**NARRATIVE
92 HALLEY DRIVE
19.17-1-36
POMONA, NEW YORK**

Re: Planning Board Applications for:
92 Halley Drive – 19.17-1-36

Nelson Pope Voorhis Review Letter dated September 5, 2023

PLOT PLAN
FOR
92 HALLEY DRIVE
19.17-1-36
HALLEY DRIVE
LOCATED IN THE
VILLAGE OF POMONA
TOWN OF HAVERSTRAW
ROCKLAND COUNTY, NEW YORK

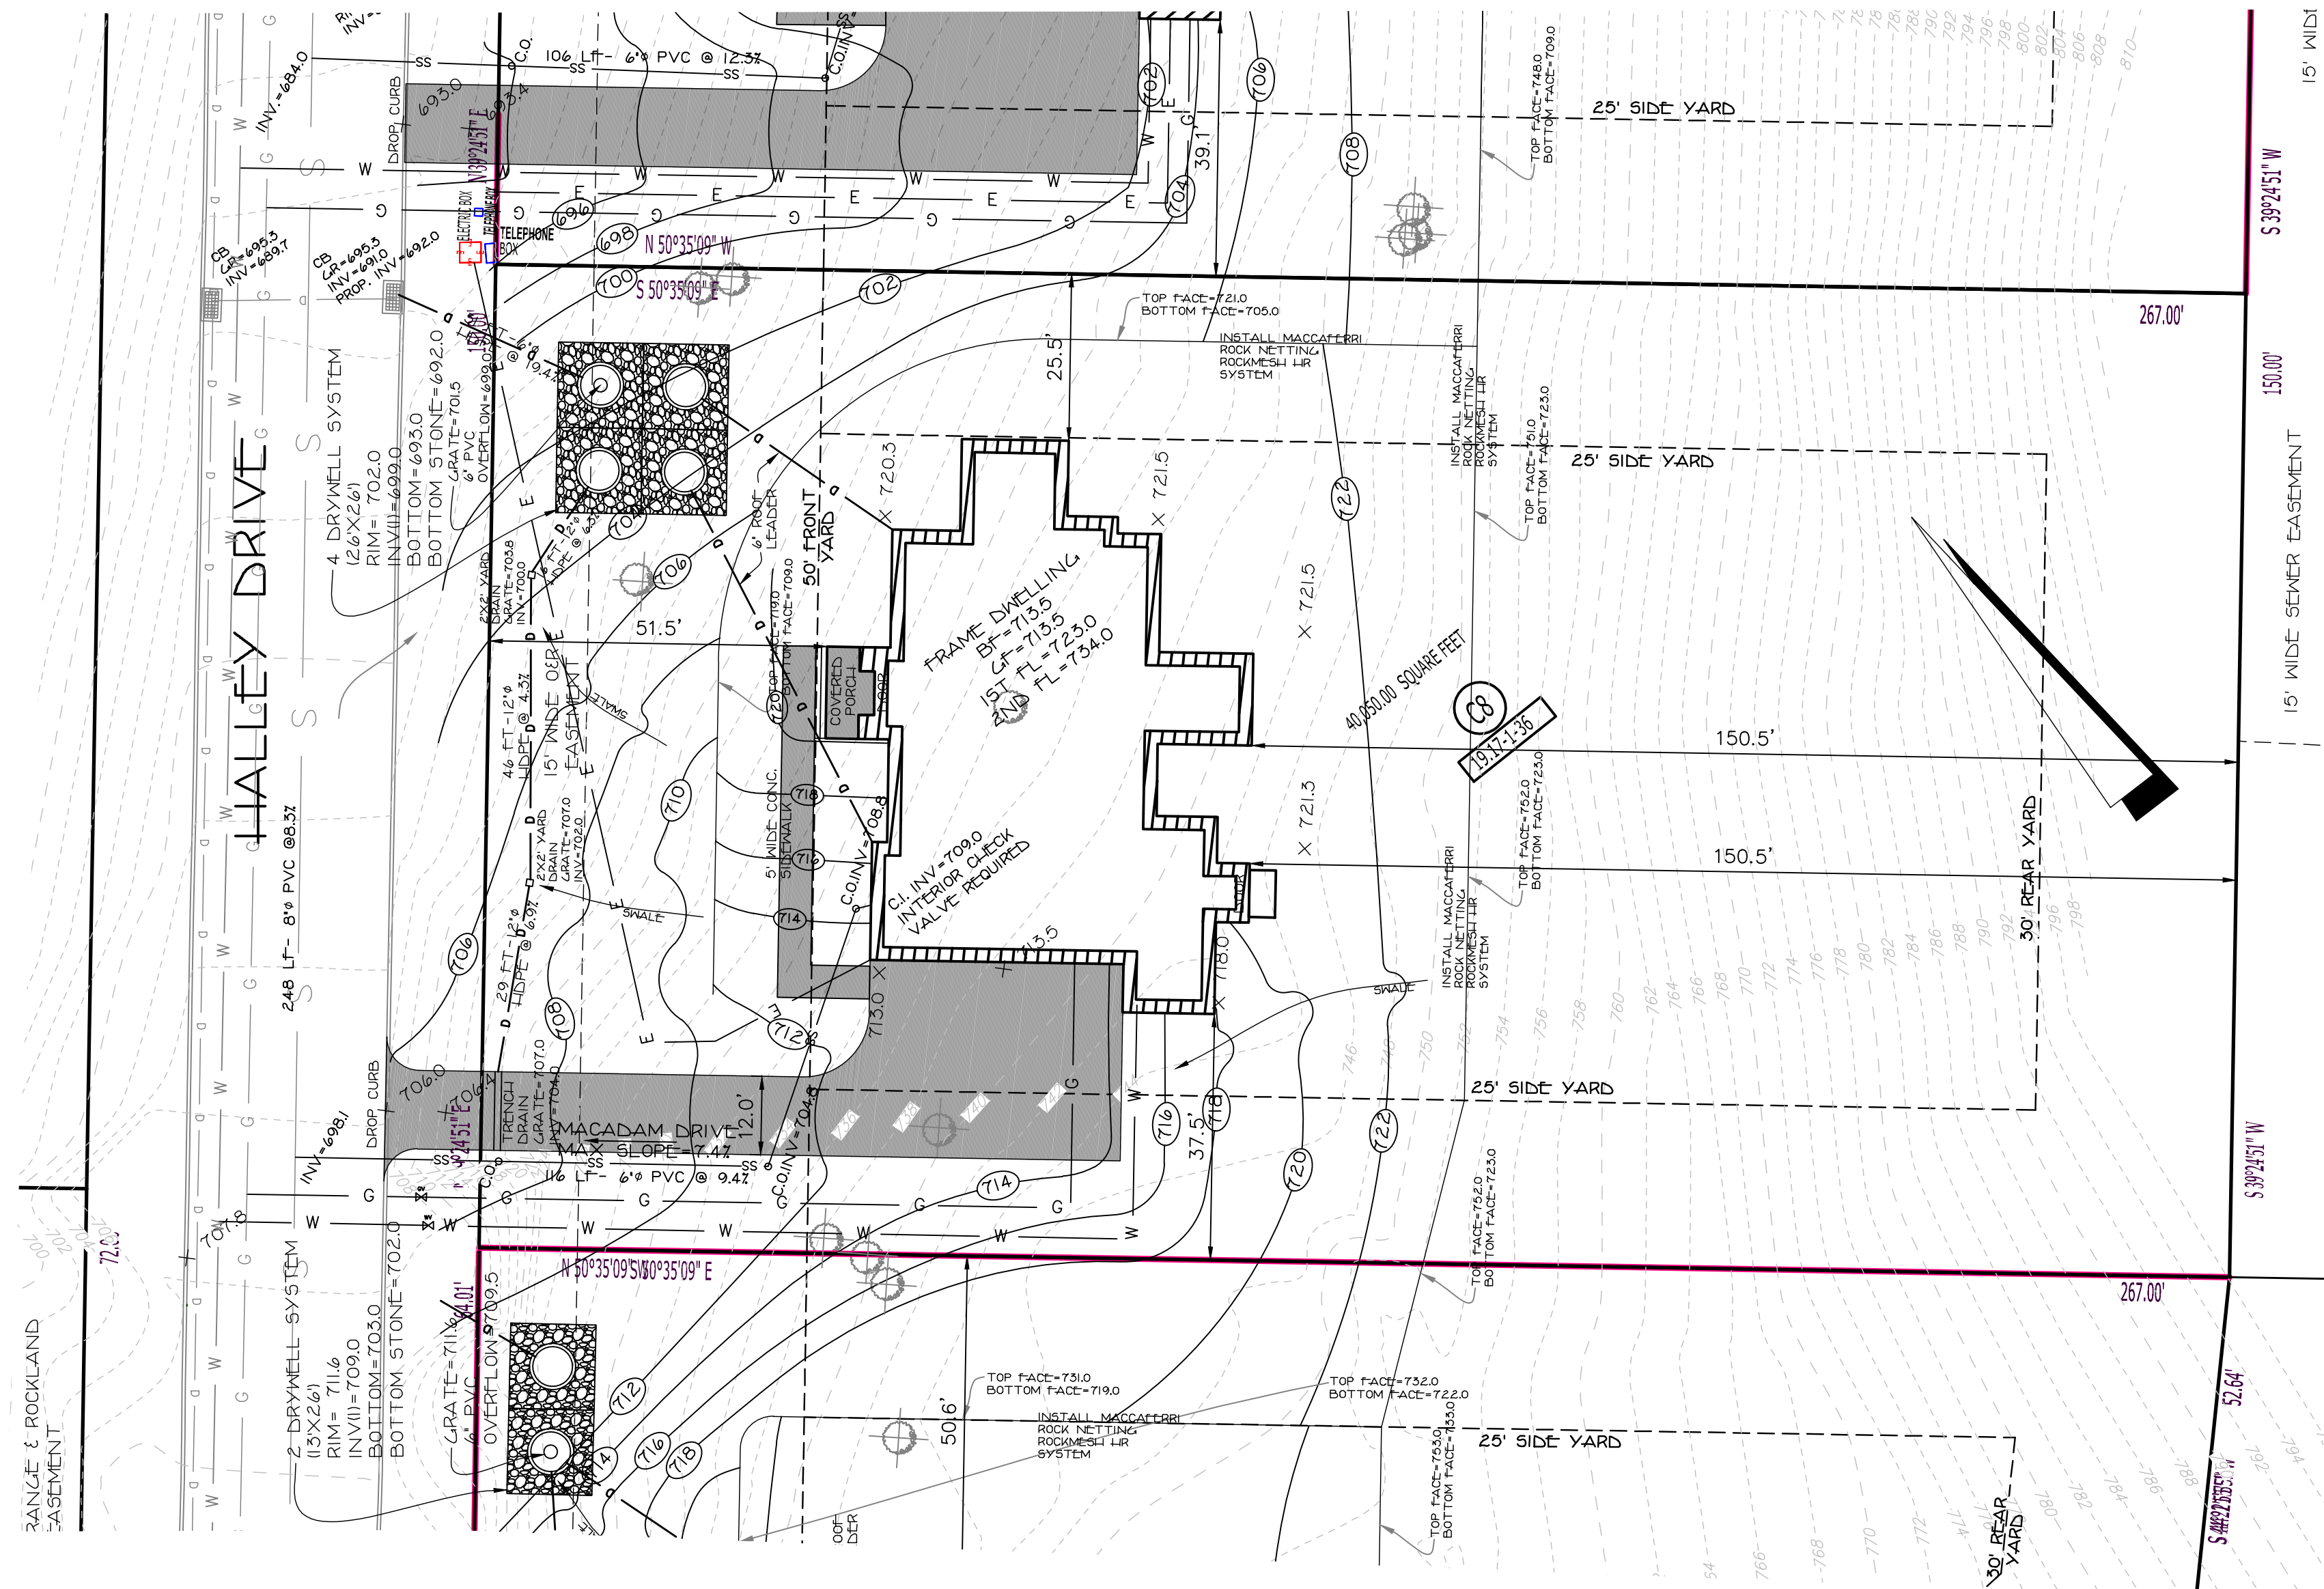
- 1) S-1. Provide title, north arrow and scale on vicinity map.
 - **Title, north arrow, and scale have been added to the vicinity map.**
- 2) S-2. Provide proposed height of building in bulk table.
 - **The proposed height is provided.**
- 3) S-3. Graphic scale missing “10” (all plans).
 - **The graphic scale has been corrected.**

- 4) S-4. Provide size of drywell area.
 - **The size of the drywell area has been added to the callout for the system.**
- 5) S-5. Label width of driveway.

- 8) S-8. Show door locations on plan. All entrances should have concrete (or other appropriate material) landing area. Architectural plans show an entrance to the garage with a concrete sidewalk on the north side of the building.

- 10) S-10. Provide roof drain size and note that all roof drains shall be connected to the on-site stormwater system.
 - **Roof leaders are now labeled with size. A note has been added to the drywell detail that all leaders are 6" diameter and are to be connected to the drywell system.**

- 11) S-11. Show water and gas connections in the street; clarify if new road openings are required or are utilities stubbed behind the curb line.
 - **New road openings are not required. The utilities are existing and stubbed behind the curb line. Water and gas valves are now shown behind the curb line.**

- 13) S-13. Label drop curb at driveway.
- **Drop curb is now labeled.**
- 14) S-14. ORU should review improvements in the easement.
- **Comment noted. We will provide plans to ORU for review.**

- **Driveways are now labeled with width.**
- 6) S-6. Show material and size of front walkway; provide detail.
 - **The walkways are now labeled with "5' wide conc. Sidewalk". A detail has also been provided for "standard concrete sidewalk".**

- **Door locations have been added. The garage door on the north side has been removed on lots 23 and 24.**
- 9) S-9. Provide cut/fill summary.
 - **Approximate cut/fill calculations have been completed. The cut/fill amount is stated within the limit of disturbance notation on the plans. The results are as follows:**

LANDSCAPING & EROSION CONTROL
FOR
92 HALLEY DRIVE
19.17-1-36
HALLEY DRIVE
LOCATED IN THE
VILLAGE OF POMONA
TOWN OF HAVERSTRAW
ROCKLAND COUNTY, NEW YORK

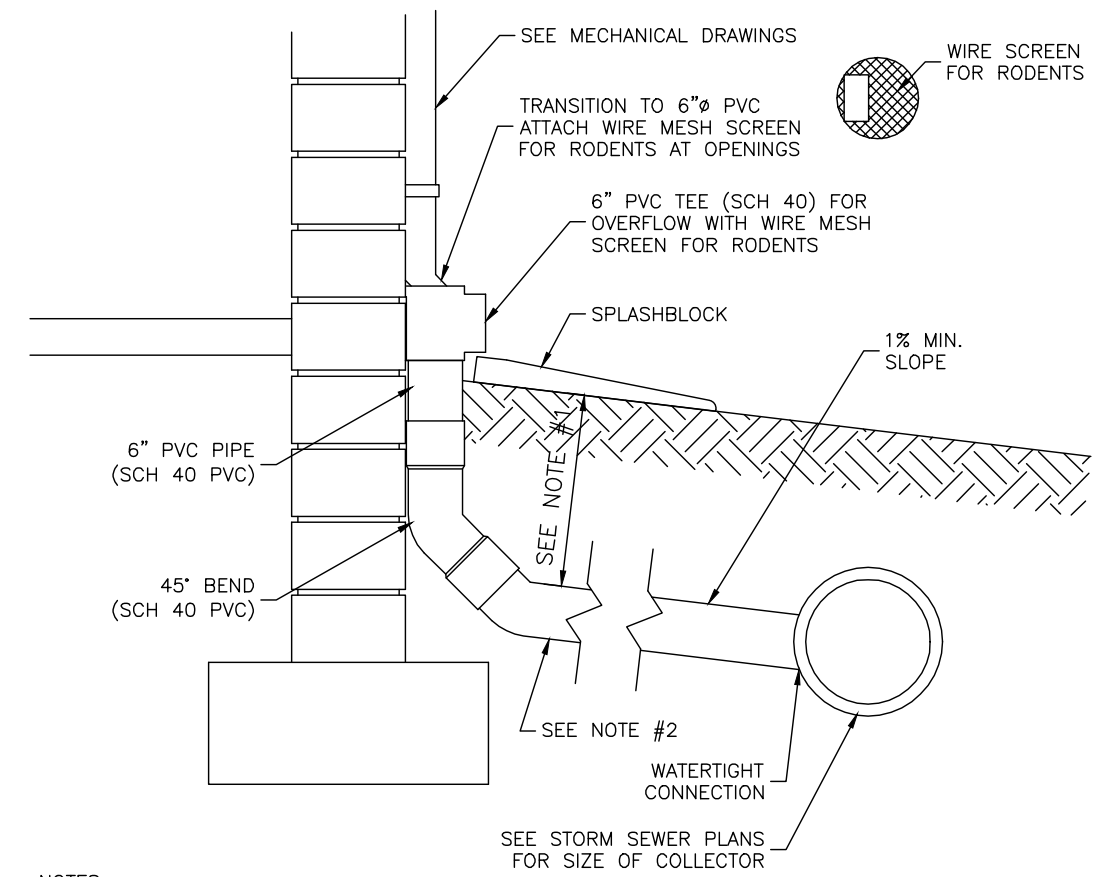
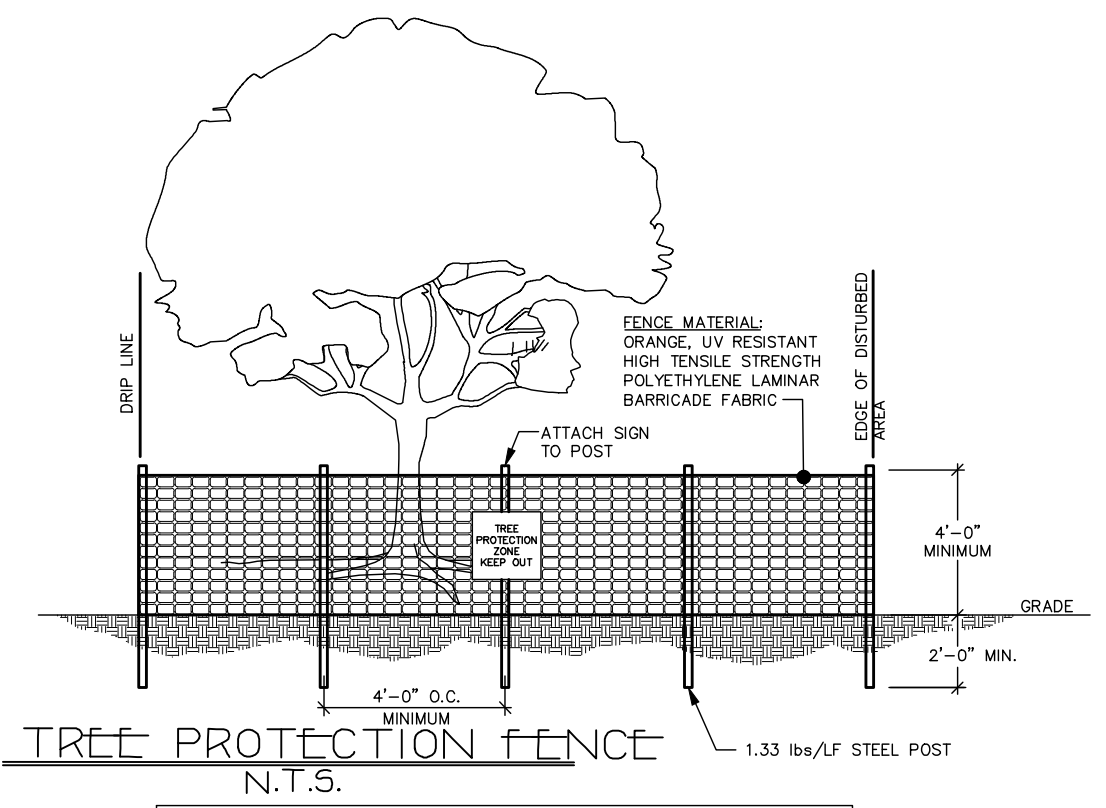
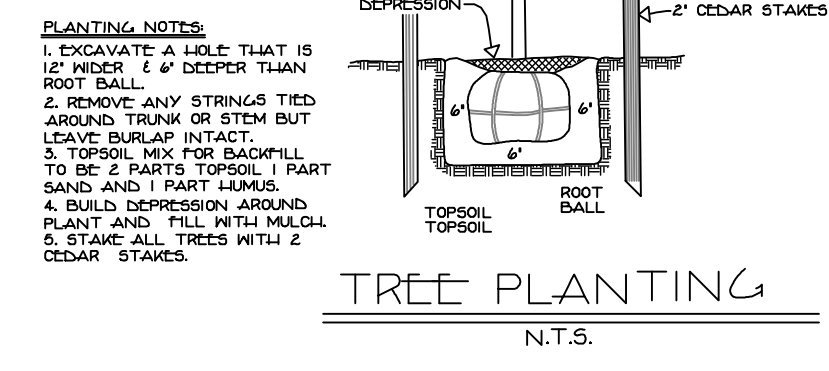
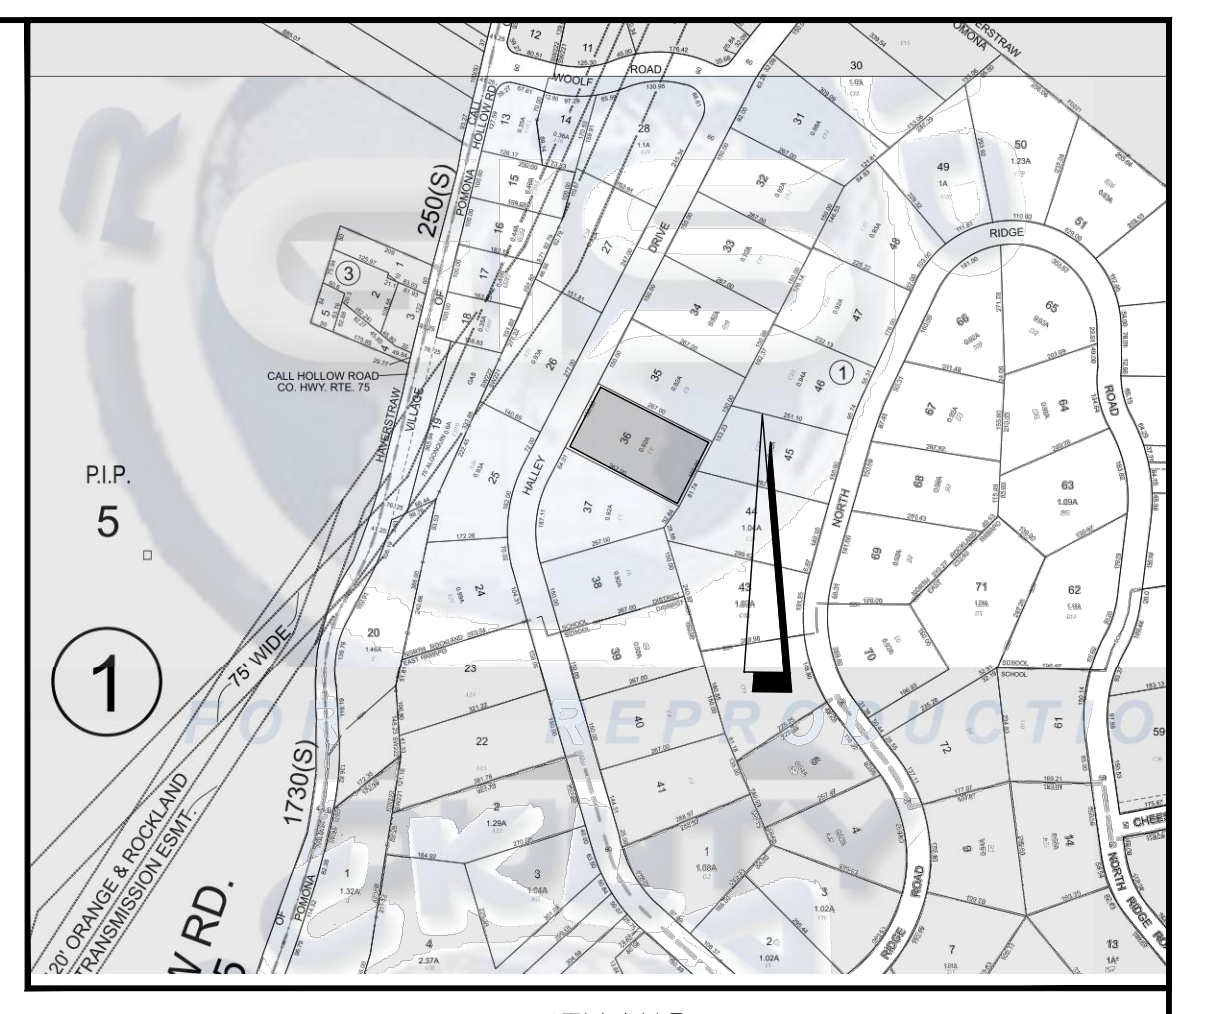
- 15) S-15. Provide foundation plantings (a typical layout for all lots is acceptable).
- **Foundation plantings are now shown. They have been added to the planting schedule.**

- 16) S-16. Provide a tree protection detail.
- **A tree protection detail, tree planting detail, and shrub planting detail have been added to the landscape sheet.**

- 20) S-20. Provide roof drain detail.
- **A roof drain detail is now provided on the landscaping sheet.**
- 21) S-21. Provide planting details.
- **Shrub and tree planting details are now provided on the landscaping sheet.**

- **Additional landscaping has been added for retaining walls.**

STEEP SLOPE PLAN
FOR
92 HALLEY DRIVE
19.17-1-36
HALLEY DRIVE
LOCATED IN THE
VILLAGE OF POMONA
TOWN OF HAVERSTRAW
ROCKLAND COUNTY, NEW YORK

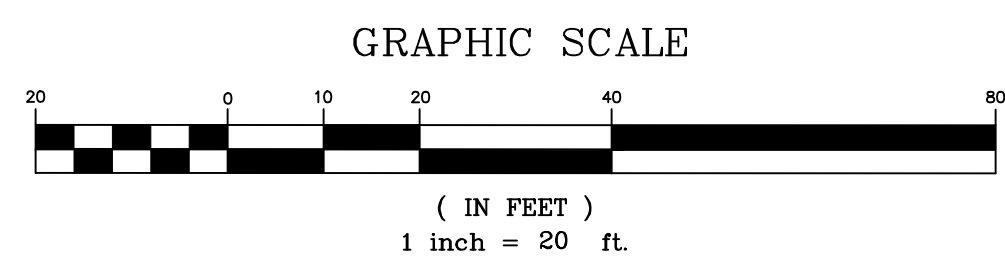
- 2) Steep Slopes: ...The shading chosen for different slope categories does not seem to include any areas on the lots with slopes flatter than 15%. On lot 23 it appears that the measured square footage in the slopes table does not correspond to the shaded areas on the map. The applicant should clarify the type of hatching used for slopes greater than 35% to distinguish from slopes less than 15% and verify the amount of square footage in the Extremely Steep, Very Steep and Moderately Steep Slope categories corresponds with the steep slope areas shown on the slope plan sheets.

- 17) S-17. Slope Table patterns should match scale of the plan; 35% - 100% slope pattern is not clearly shown.
- **The hatch pattern for 35%-100% slopes has been changed to a transparent solid hatch, which should make the slope plan legible.**

- **Slopes flatter than 15% are not shaded as there isn't a special requirement for these areas. Lot 23, 24, 25, and 36 only have small areas of slopes less than 15%. Lot 37 contains some areas less than 15% slope. Again, areas not shaded or hatched are flatter than 15%. The hatching is clarified within the slope legend. There are three different hatch types on each lot and these are differentiated from slopes less than 15%, which are not hatched.**

- **We have corrected the slope areas for lot 23 and verified others. Planning Board approval is required for disturbance to steep slope areas on each lot.**
